THE LAND COURT OF QUEENSLAND

File Numbers: MRA082-13 & EPA083-13

Applicant: **HANCOCK COAL PTY LTD (ACN 130 249 973)**

JOINT EXPERTS REPORT ON GROUNDWATER

Figure: 6b

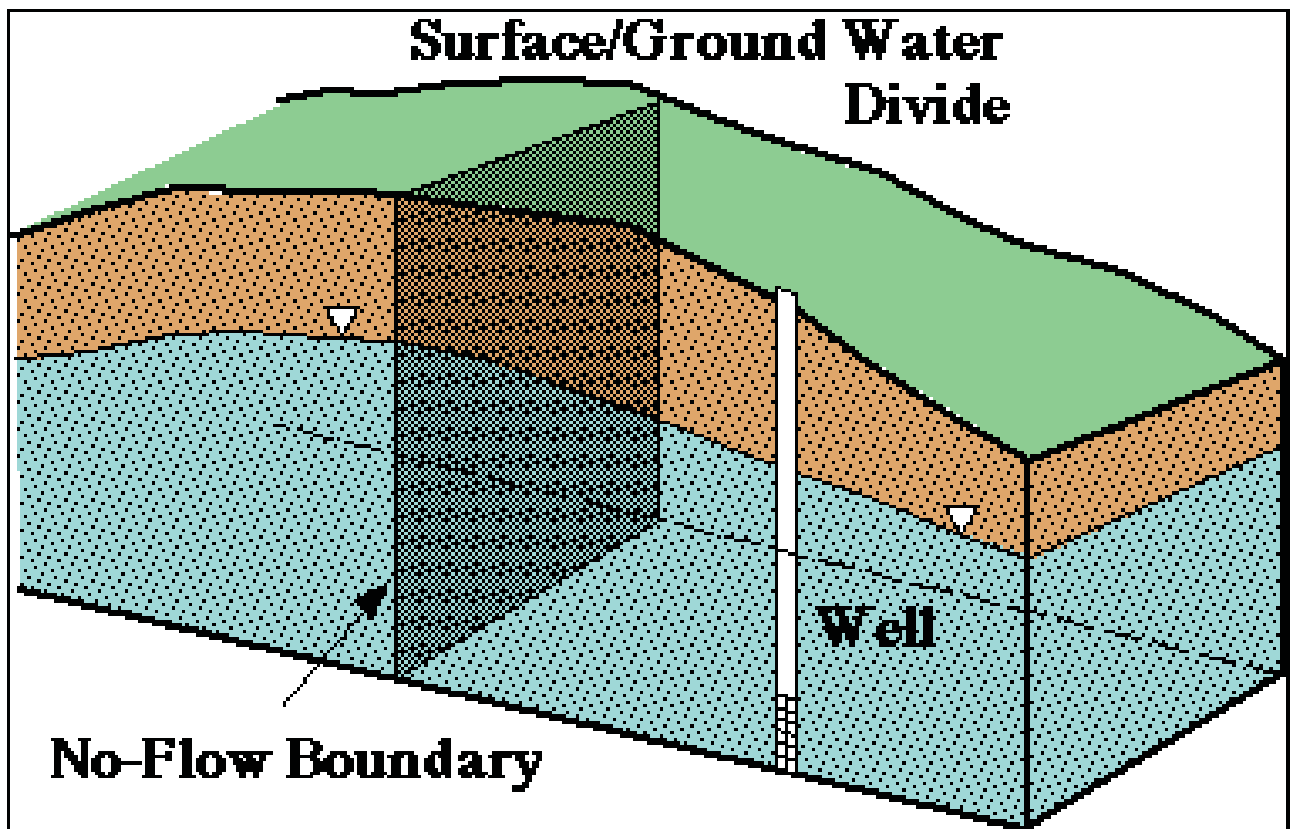
75. The Salva Resources GAB Report (memorandum dated 18 February 2009) provided a plan view of formation subcrops (Appendix A Figure 6a) and a west-east cross-section across the GAB and Galilee Basin (Appendix A Figure 6b). According to the Salva Resources memorandum the regional geological model had been compiled based on:

Figure: **7**

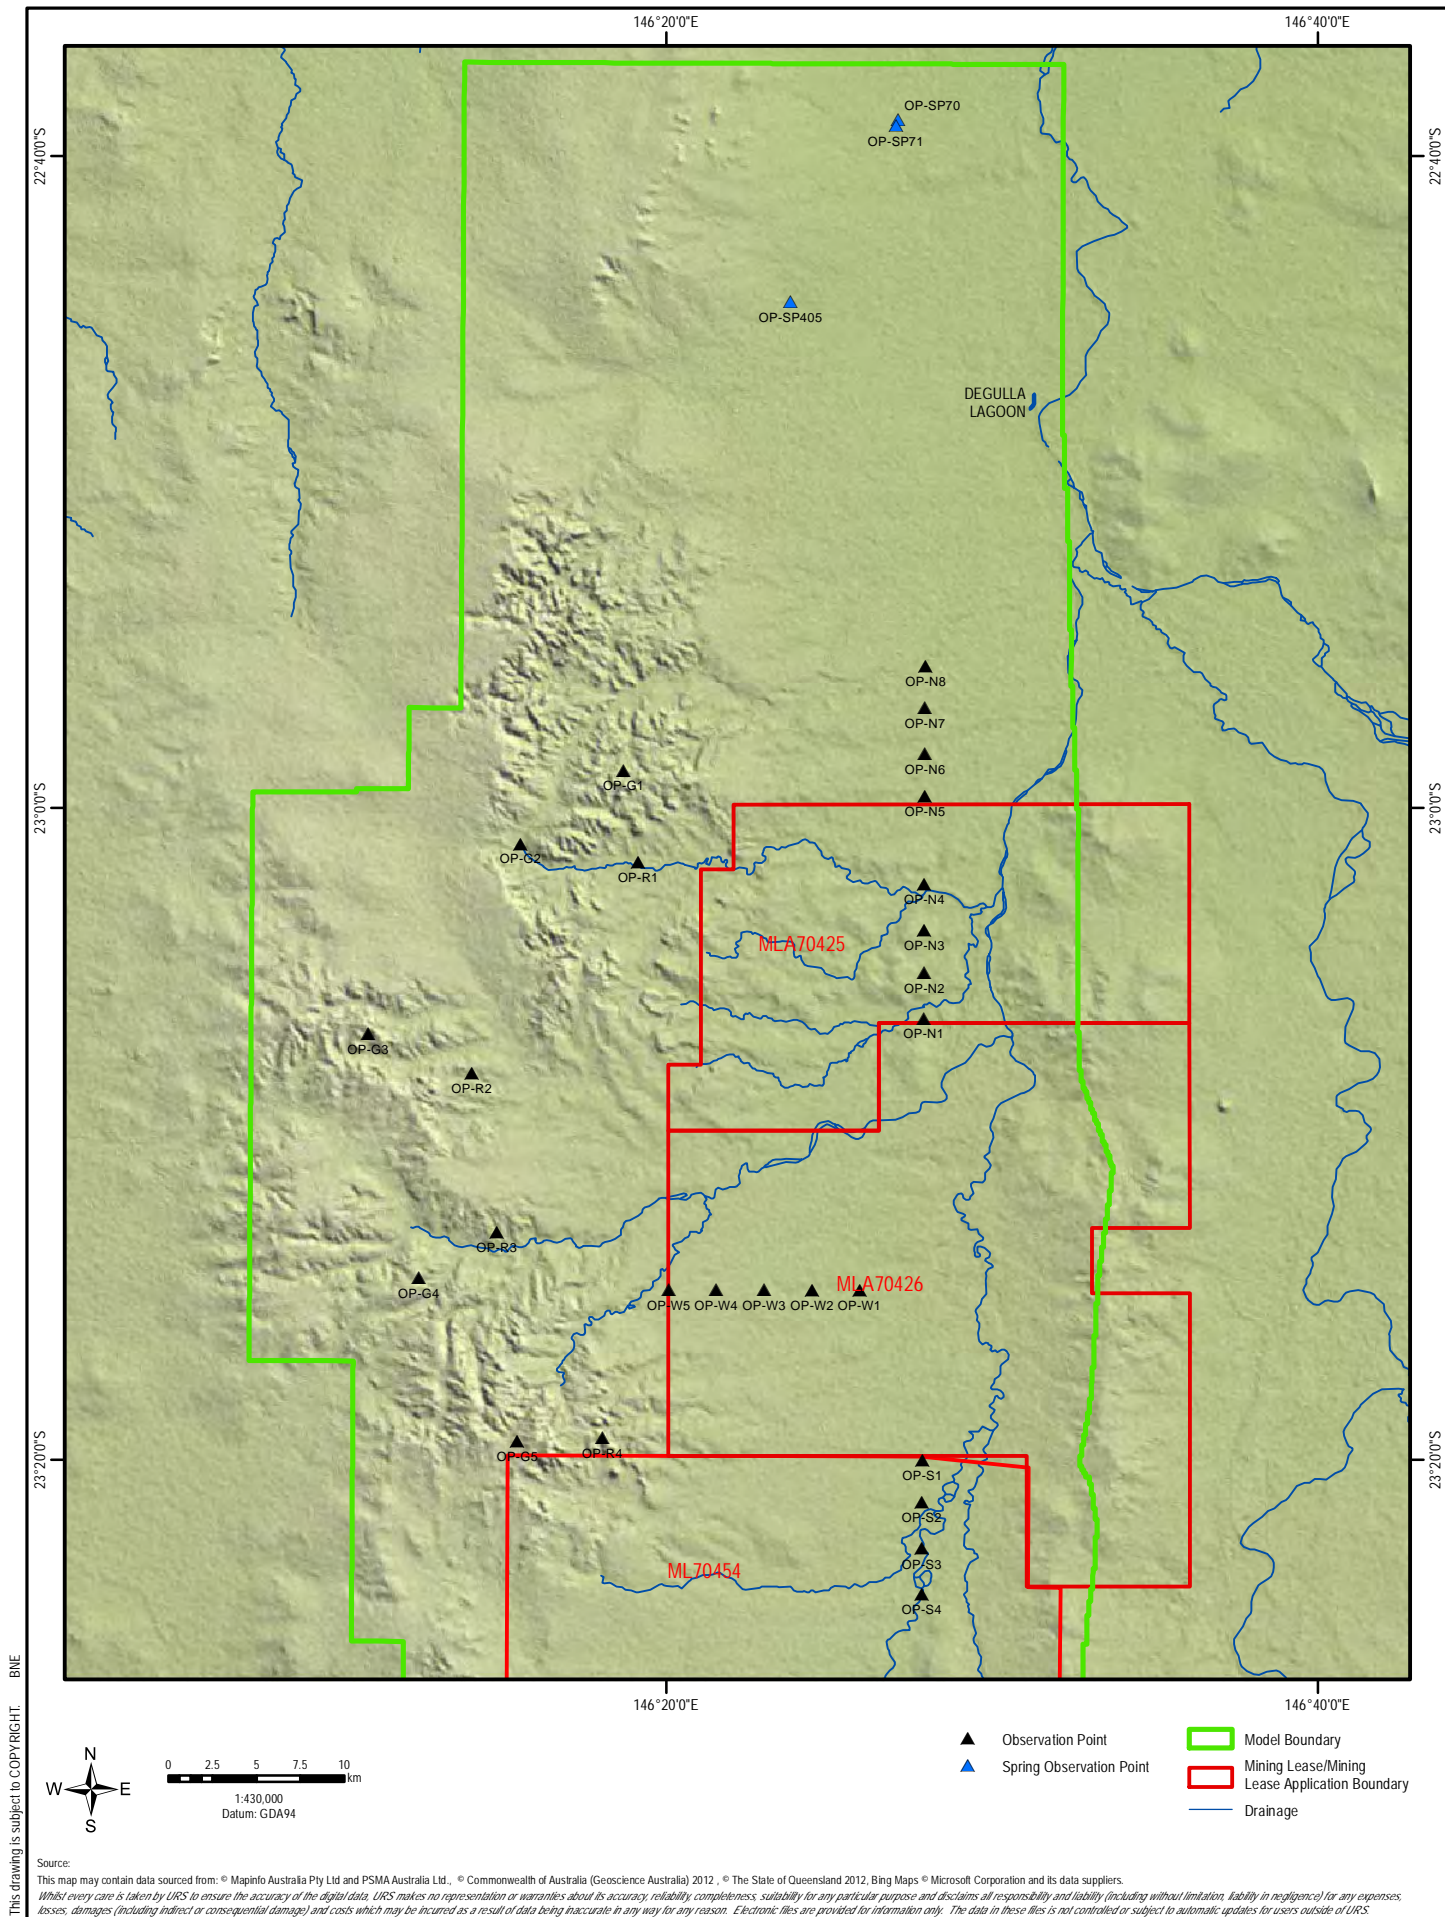
105. Appendix A Figure 7 shows a sketch of the no-flow boundary, which is used in groundwater models to simulate surface or groundwater divides.
106. Point 28 above includes comments on the conservative nature of the use of the no-flow boundary closer to the Alpha Coal Mine than the actual no-flow boundary where the Permian units pinch-out against the Drummond basement. It is also considered that when a no flow boundary is used to represent a ground water divide, drawdown may be overestimated, as the groundwater model does not facilitate ingress from the hydraulic connected units to the west of the no-flow

Figure: **9**

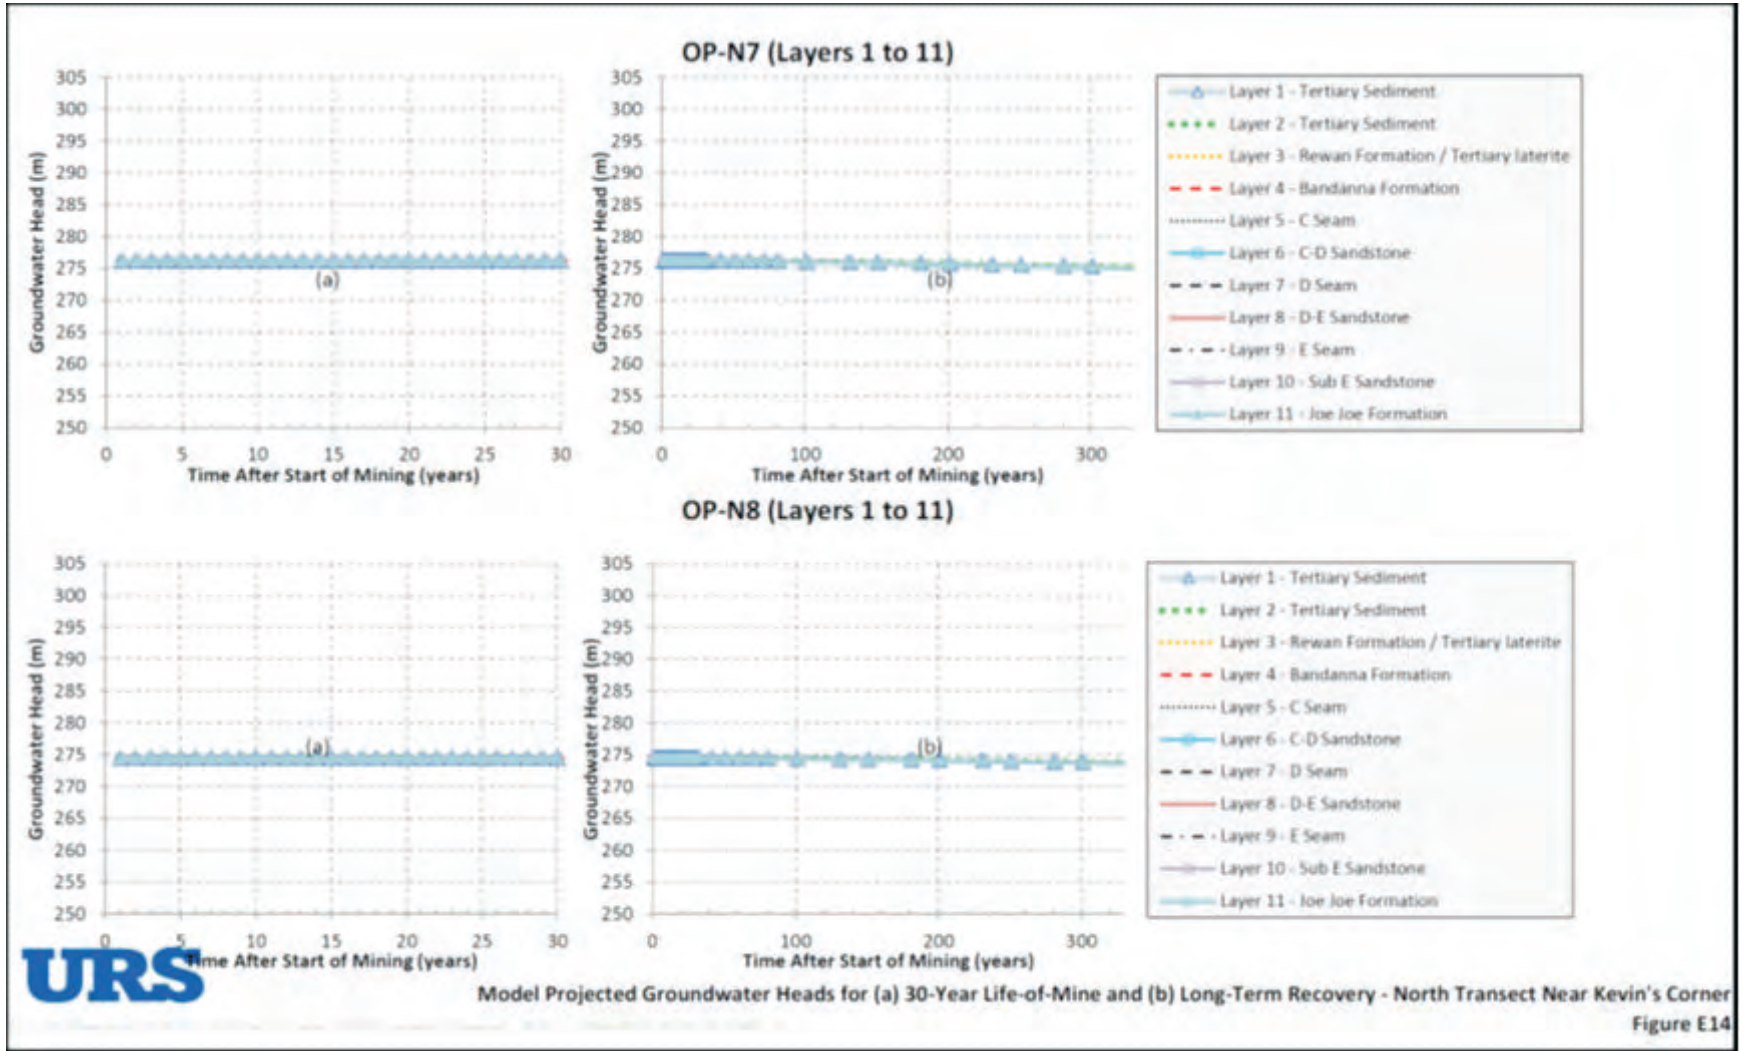
140. Groundwater level drawdown and propagation in each of the layers was also considered during the predictive modelling, through the inclusion of observation points within the model domain. For the drawdown impact evaluation and to evaluation potential impacts of induced flow (from over and under lying units to the depressurised D coal seam outside of the Alpha Coal Mine) eight (8) observation points were included north of the Alpha Mine Lease boundary (Appendix A Figure 9), labeled OP-N1 to OP-N8.

208. Consideration of Degulla Lagoon was conducted during the Kevin's Corner EIS study, in response to comments received from the owner of Degulla Lake who stated that the Degulla Lake is filled by the overflow water from the Belyando River during flood events. Note Degulla Lagoon is presented on Figure 9 Appendix A.

Figure: **11a**

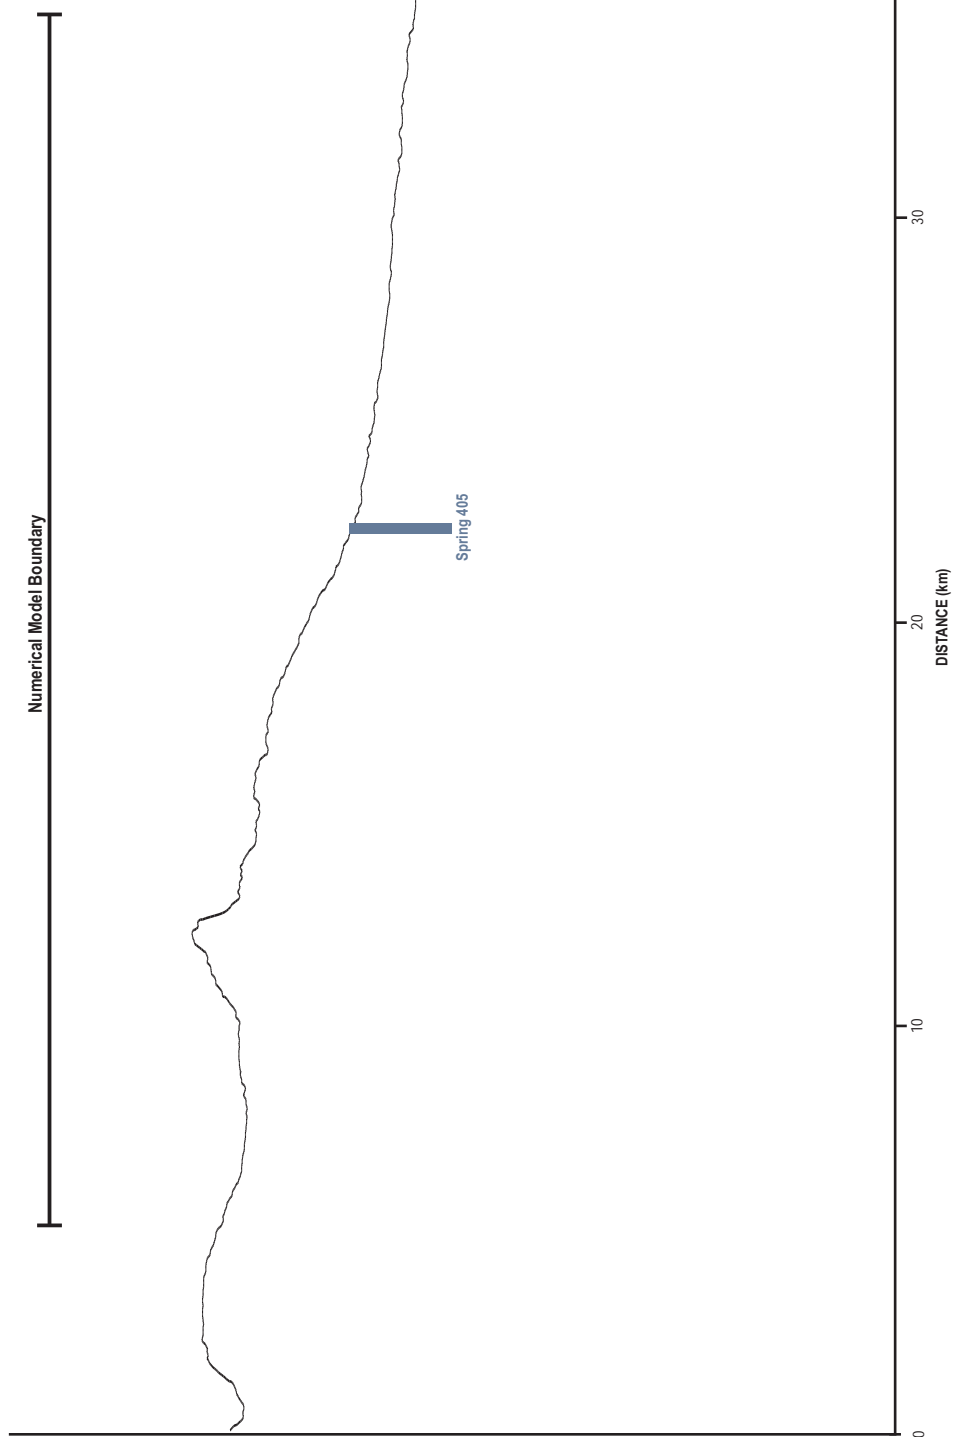
- The location of the springs, along a north-south direction, adjacent to a change in slope (Appendix A Figure 11a and Figure 11b);
- The springs appear to emanate at the topographic break of slope, where shallow groundwater is moving west to east from recharge areas on the Great Dividing Range, and discharging at the break of slope at points that also correspond with surface drainage lines;
- A review of hydrology and satellite imagery indicates that these springs are ephemeral (i.e. no perennial surface water flows from these registered springs).
